Model: T-G1/T-G1N/Pi-G1N		Date: 8-Sep-06	No.: MJ007001
Modified Article: NVRAM		Prepared by: Hiromoto Saitoh	
From: 1st Tech. Support Sec. Service Support Dept.			
Reason for Modification:	☒ Parts catalog correction ☐ To facilitate assembly ☐ Part standardization	☐ Vendor change ☐ To improve reliability ☐ Product Safety	☐ Other ☐ To meet standards ()

Model: T-G1/T-G1N/Pi-G1N		Date: 13-Oct-06	No.: MJ007002
Modified Article: Endoder wheel		Prepared by: Hiromoto Saitoh	
From: 1st Tech. Support Sec. Service Support Dept.			
Reason for Modification:	☒ Parts catalog correction	☐ Vendor change	☐ Other
	☐ To facilitate assembly	☐ To improve reliability	☐ To meet standards
	☐ Part standardization	☐ Product Safety	()

-Illustration-

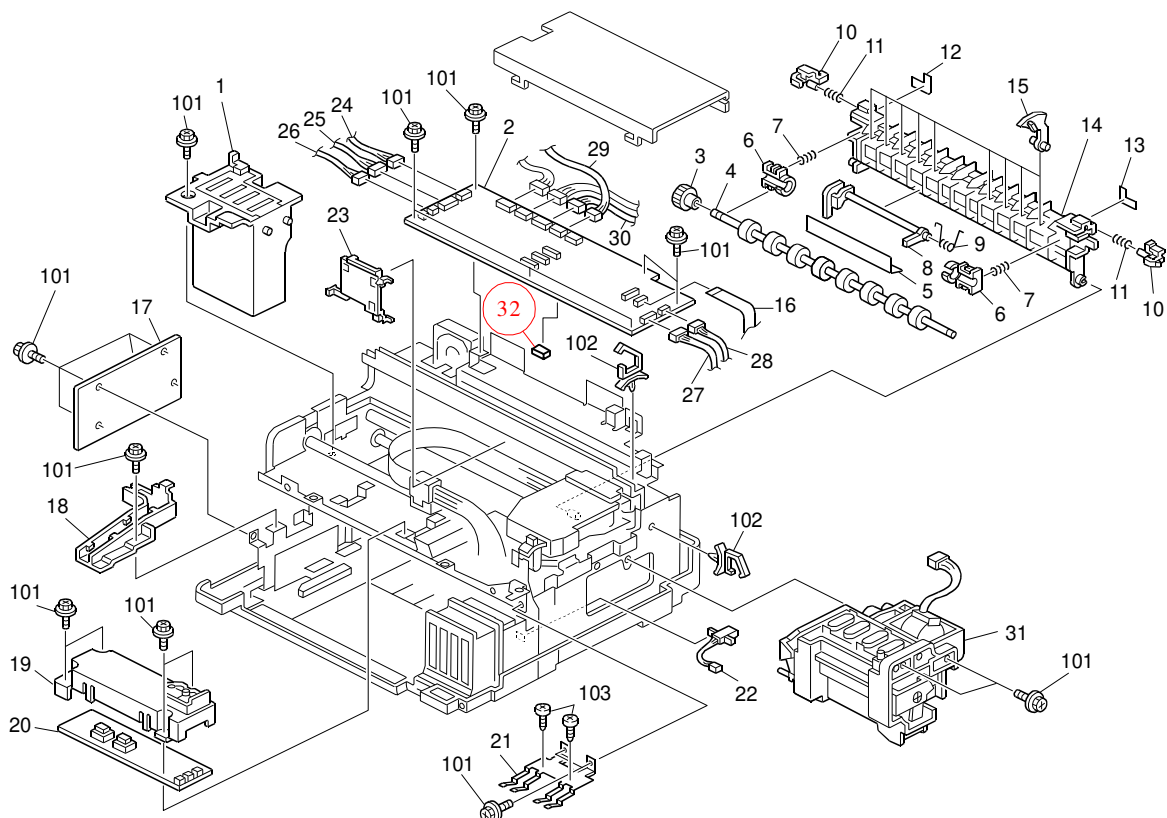
Change/Reason: This part was missing from the Parts Catalog.

-Illustration-

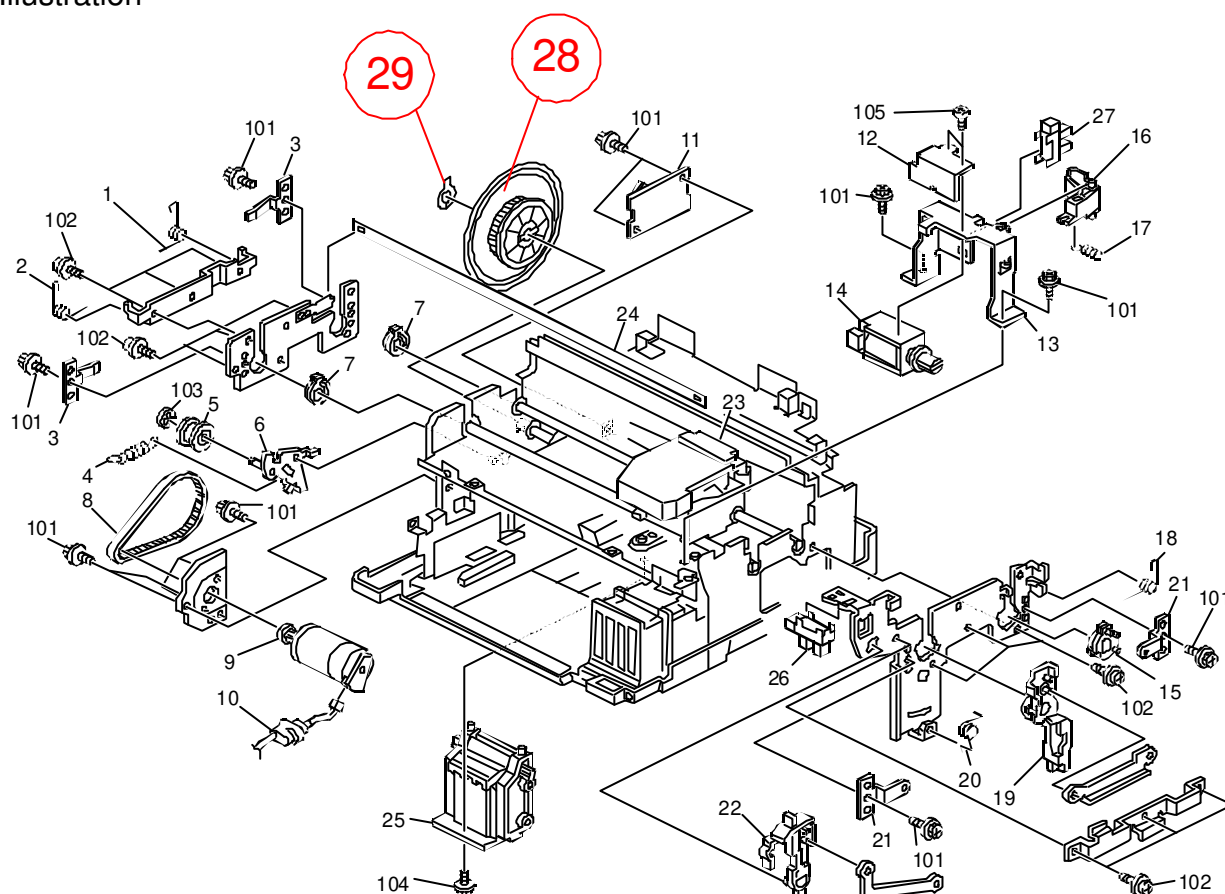
Change/Reason: These parts were missing from the Parts Catalog.

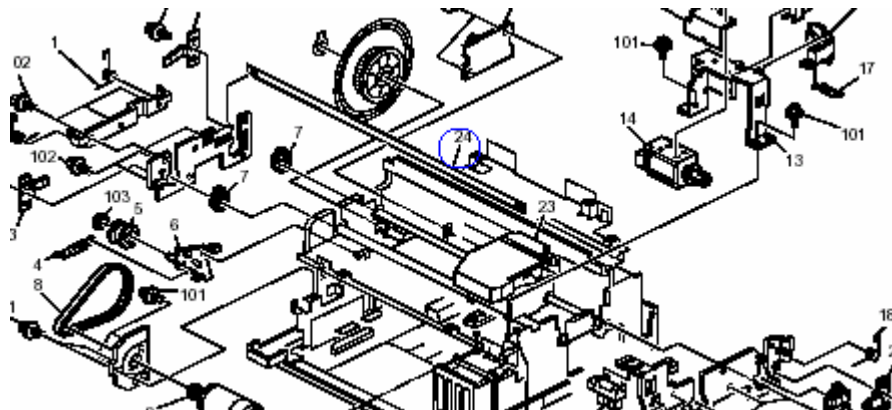
The ink collector unit changes for the consumables.

The ink collector unit was deleted from service parts, so please handle this part as a consumable*.

*** Ink collector unit GX3000 (TG1/TG1N) EDP: 405660**

*** Ink collector unit GX5000 (Pi-G1N) EDP: 405661**

Change:

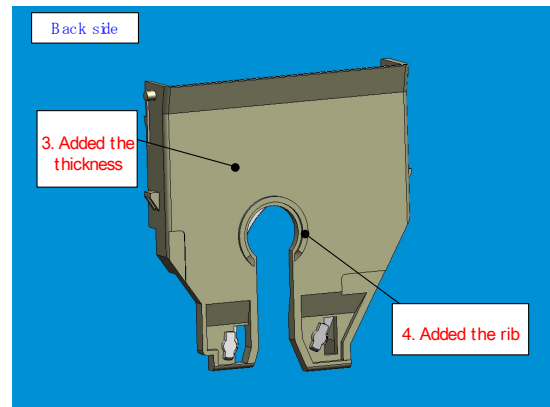
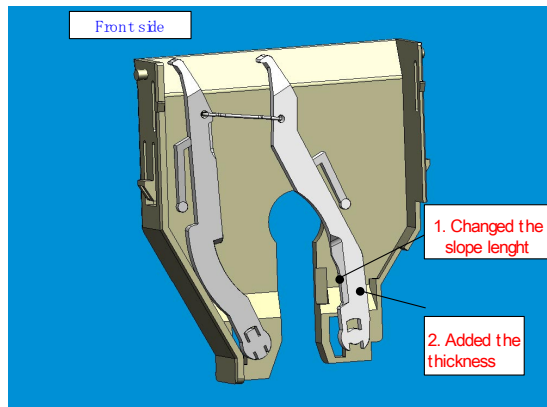
1. Changed the slope length.
2. Increased the thickness of the lever.
3. Increased the thickness of the plastic backing plate.
4. Added the rib.

Note: The illustrations above show the right flushing gate of the maintenance unit.

Reason: To improve the robustness of the maintenance unit.

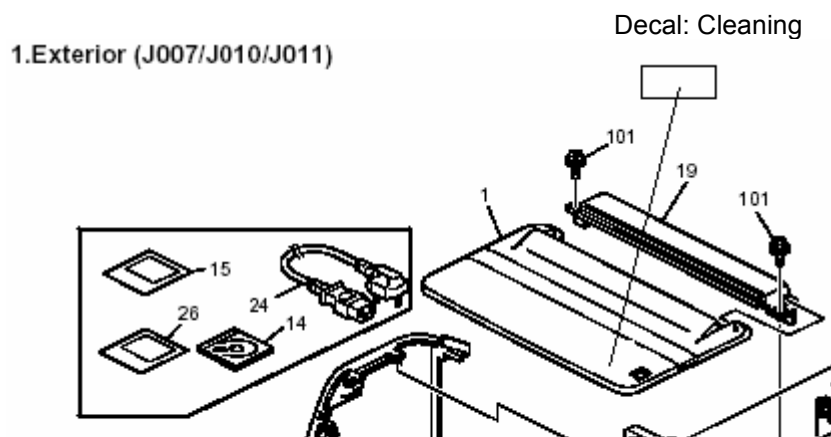
Change: Cleaning decals were added to the upper cover.

Reason: To meet requests from the field.

Note:

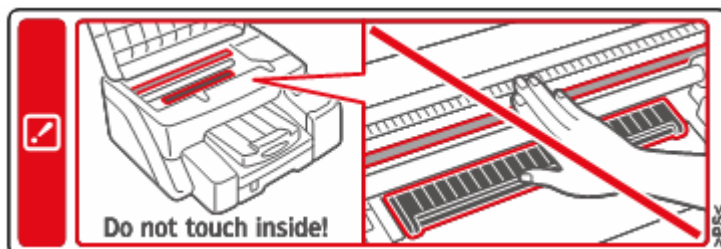
- The purpose of this decal is to make sure the user does not touch the main encoder sheet or pressure plate (because this can damage them).

- The purpose of this decal is to make sure the user loads the paper correctly. (This will decrease paper feed jams).

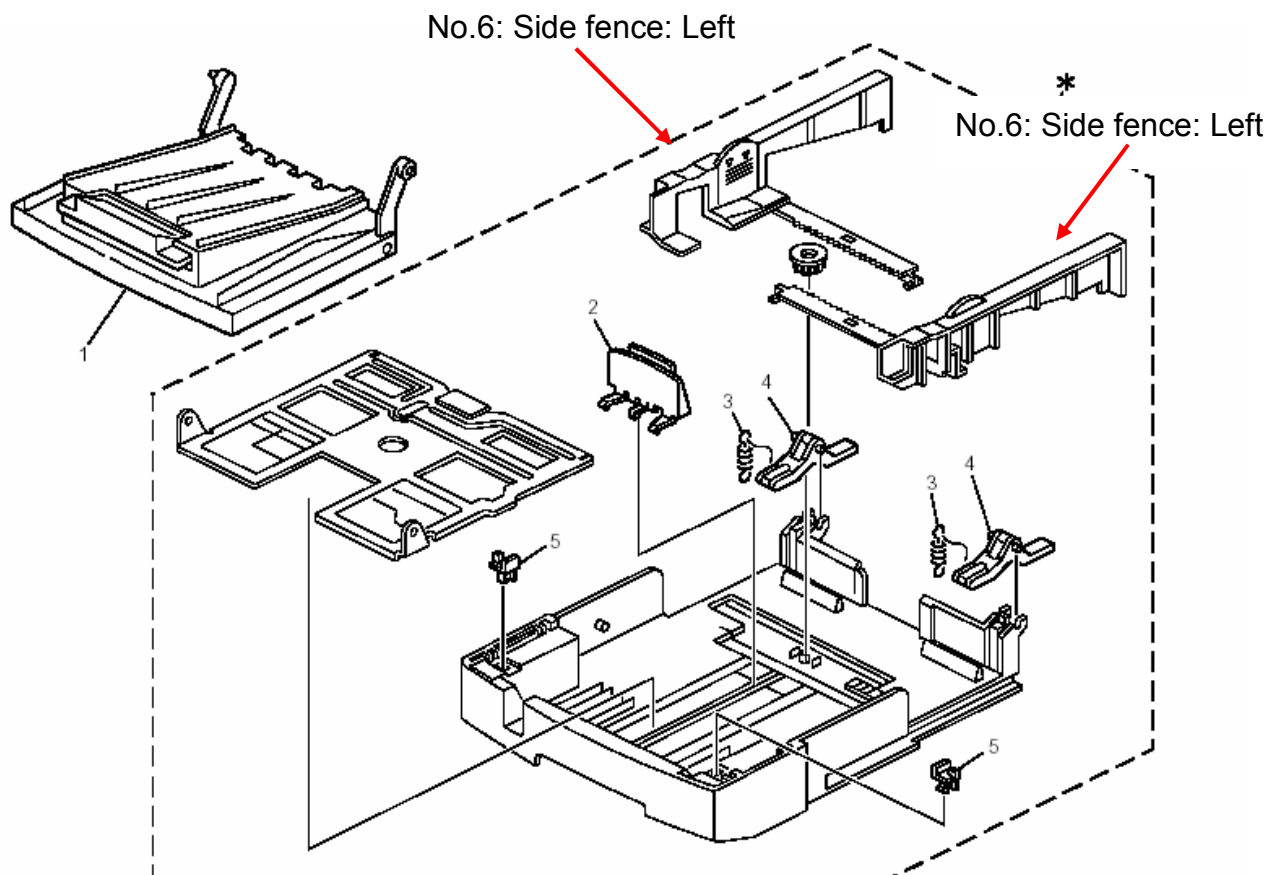
- 1) The shape of the end fence was changed.
- 2) The side fences were added to the Parts Catalog.

- 1) To further strengthen the end fence.
- 2) These parts were missing from the Parts Catalog.
